May 29, 2015

Former ASARCO East Helena Facility Interim Measures Work Plan—2015 and 2016

May 2015

FIGURE 1-2
Interim Measures Components
Proposed for Implementation in 2016
Interim Measures Work Plan—2015/2016
 East Helena, Montana

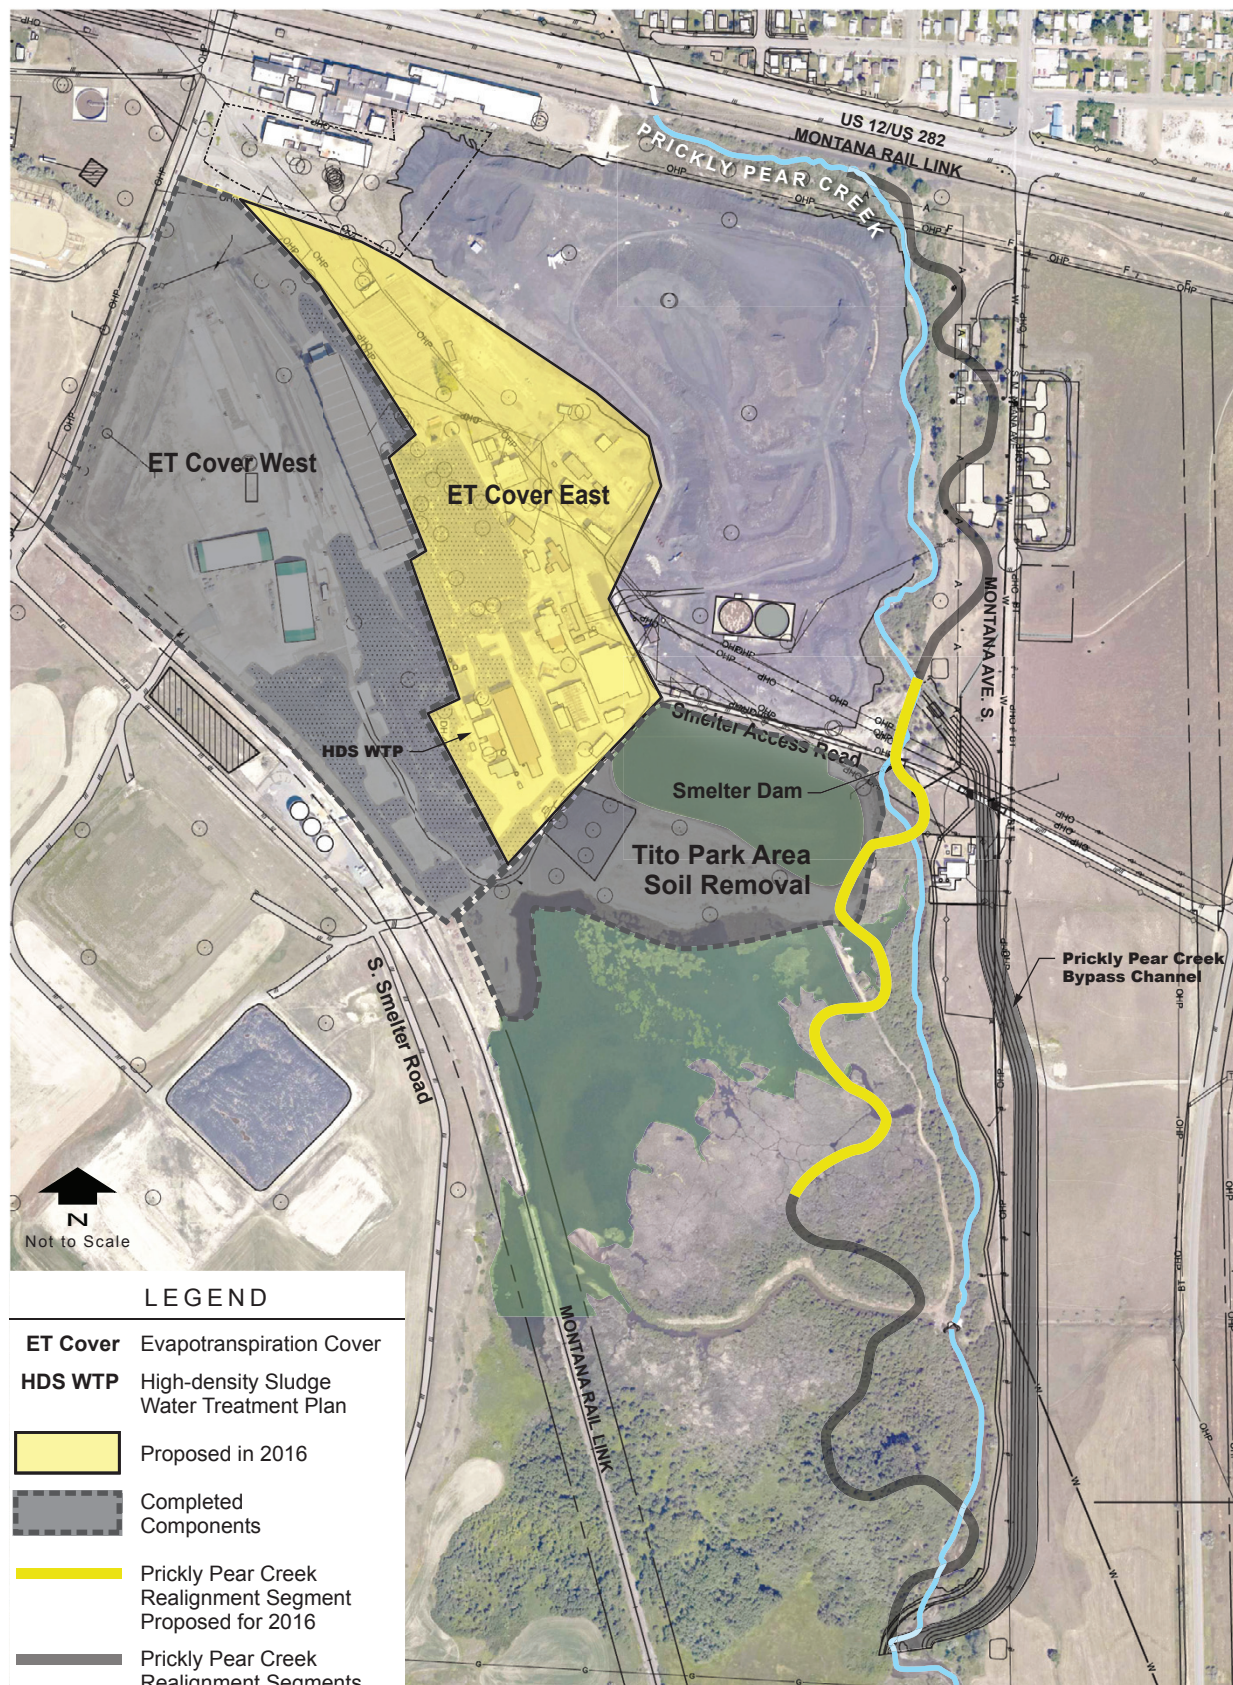
- b. "meet the function needs of the PPC Realignment" - Figure 1.2 of the 2015 IMWP clearly contradicts this statement. The active channel and floodway do not intersect with the Tito Park removal area.

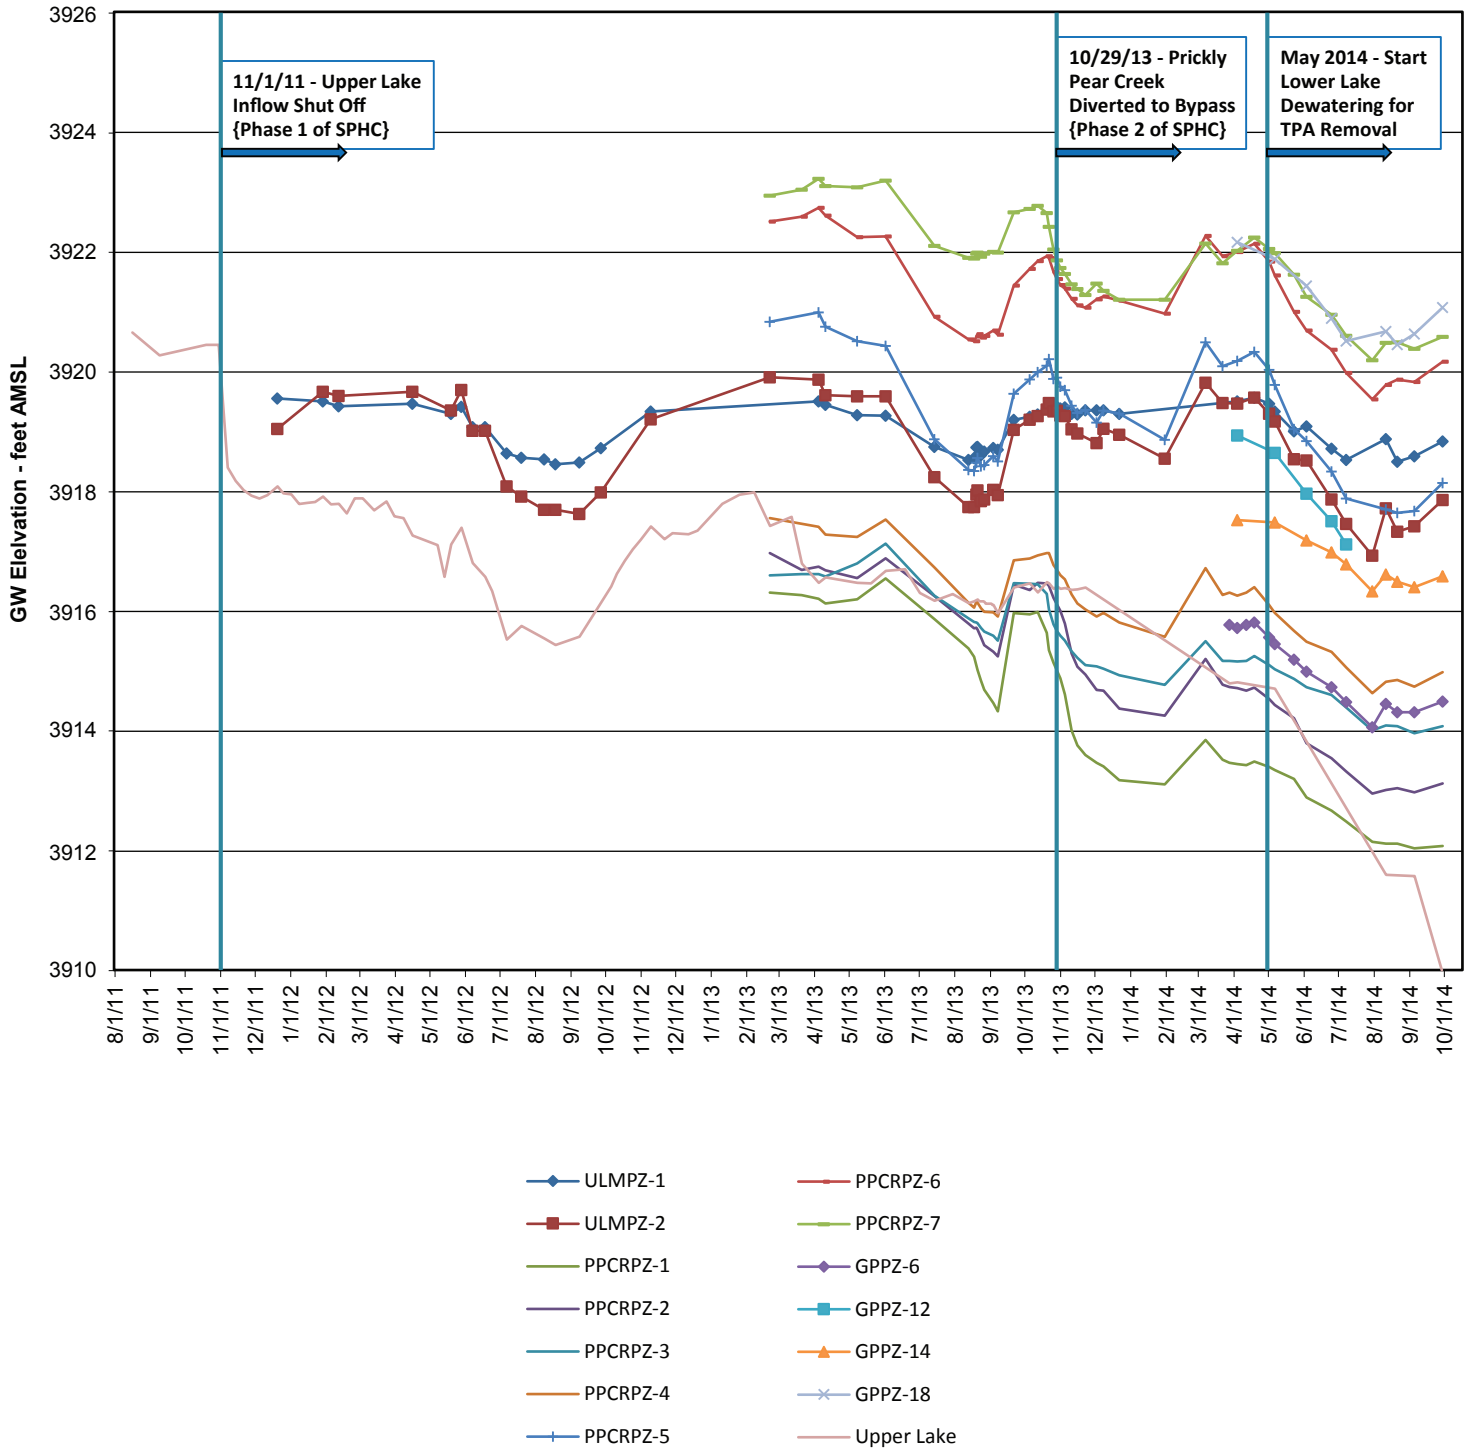
Figure 3-2. The legend is incomplete and does not identify data point locations.

EPA Response – Data point locations (wells/piezometers) are shown in Figure 3-1. A note will be added to Figures 3-2 and 3-3 indicating that “*Data locations are shown in Figure 3-1*”.
